**New Field Safety Notice**

**Urgent Medical Device Correction – Pitch Cable Failures on da Vinci X and Xi Tenaculum Forceps and Small Graptor™ (ISIFA2024-10-C)**

**Figure C: Example of a pitch cable fragment.**

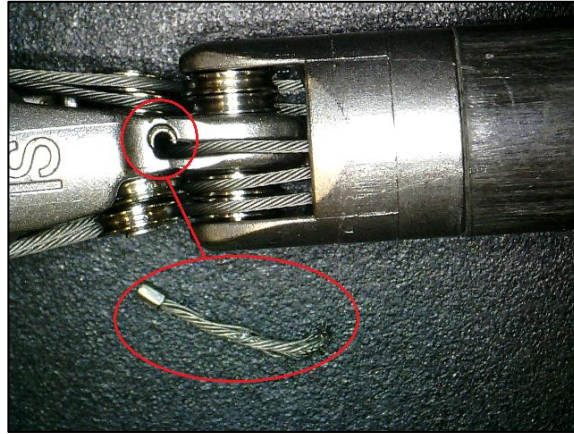
A pitch cable can fail partially (i.e., frayed) or completely (i.e., broken). A broken pitch cable can lead to loss of pitch functionality, exposure to frayed cables, or the potential for tungsten cable particulate to fall into the patient. Pitch cable failure may also result in a fragment of the pitch cable and its end-crimp becoming dislodged from the instrument (See Figure C).

Both the Tenaculum Forceps and Small Graptor use an end crimp design at the distal end, where if the pitch cable breaks it is possible for a segment of the crimp side of the cable to fall out as a fragment and into the patient.

If the instrument fails during surgery, there is potential for a fragment to separate from the pitch cable as shown in Figure C. Visible fragments can be extracted by the surgeon with surgical instruments or irrigated and suctioned out of the patient. Such attempts to retrieve material could lead to a prolonged surgery. Retrieval of fallen particulate by the user may incur a minor procedure delay (< 30 minutes).

If you experience a cable failure, please be sure to inspect for any fragments before completing the procedure.

Figure E: Example of a pitch cable fragment.

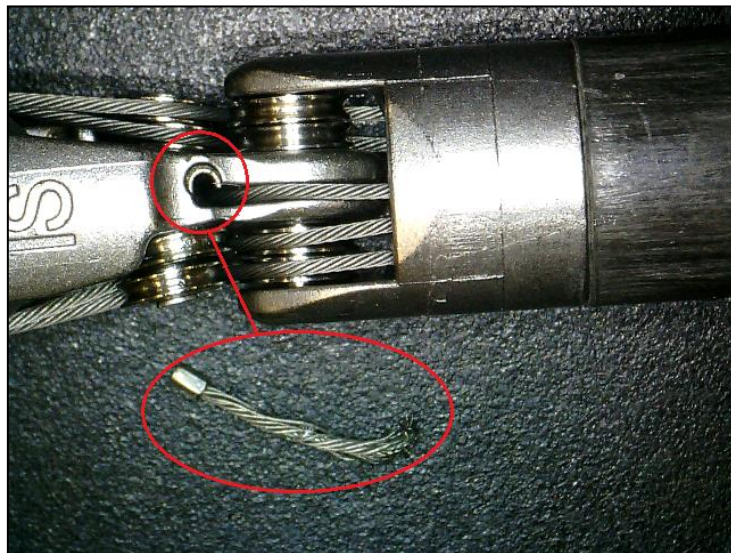
Prior to use, visually inspect all instruments for broken or frayed cable per Figure E, F and G below
